LANDMARKS BOARD

January 9, 2013
5:30 P.M.
Council Chambers
City Hall (830 Boonville)

STAFF REPORT

WALNUT STREET URBAN CONSERVATION DISTRICT – EAST

EAST ELEVATION
3/16" = 1'-0"

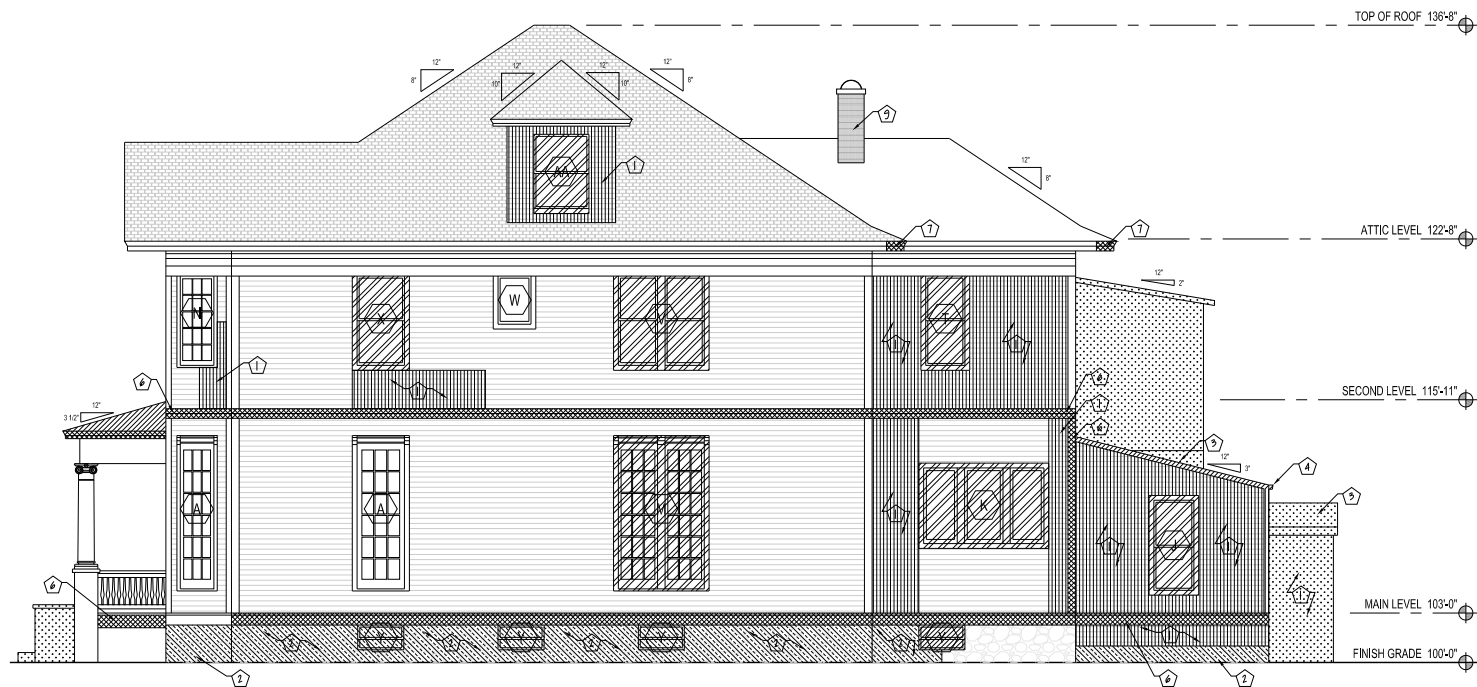
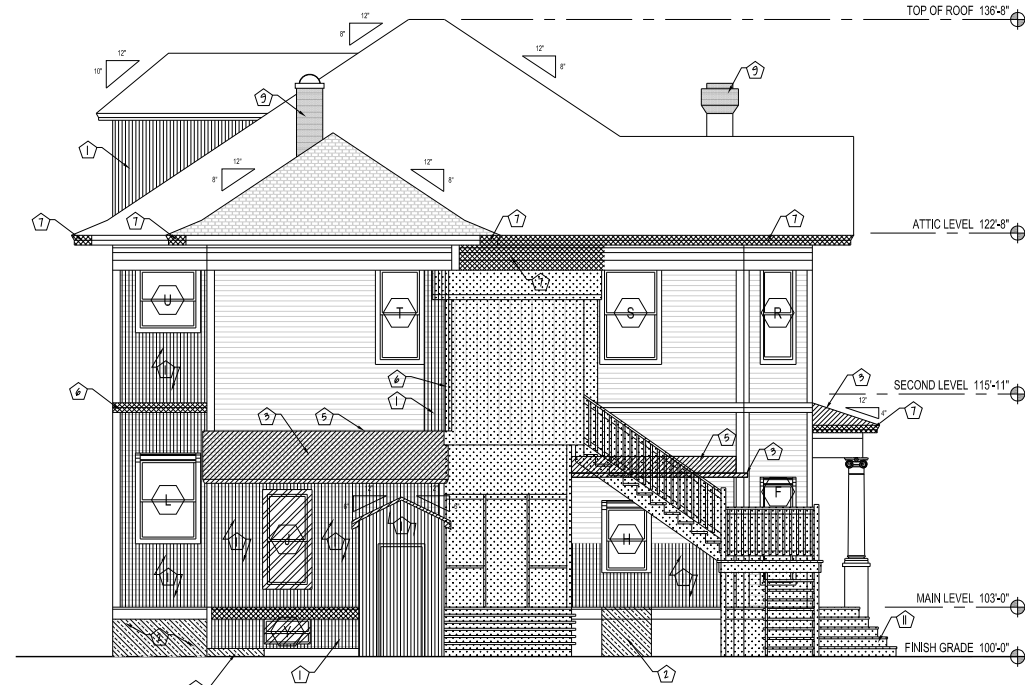
Staff recommends **approval** of most items; however, the board will need to determine whether HardiePlank cement board is an acceptable replacement material for wooden lap siding.

1. Most of the proposed exterior renovations follow the Walnut Street Design Guidelines except the replacement of the wood siding. The Landmarks Board will need to determine whether the HardiePlank cement board is an appropriate replacement for the existing wood lap board siding. Staff has included a couple articles (attached) that have been posted regarding HardiPlank siding compared to wood lap siding. While the Walnut Street Design Guidelines do not specifically prohibit cement board siding, the Secretary of Interior's Standards recommend materials that can be found within the same period in which the structure was built or a prominent era. Staff is not aware of another certificate of appropriateness where cement board has been used in the district. Staff supports all other proposed exterior changes.

- 1) REMOVE SIDING- REPLACE WITH JAMESHARDIE HARDIEPLANK CEDARMILL 125 LAP SIDING IN 6 1/4" WIDTHS
- 2) REPAIR STONE AND CMU FOUNDATION- FILL CRACKS WITH NON-SHRINKING GROUT- MATCH EXISTING GROUT COLOR
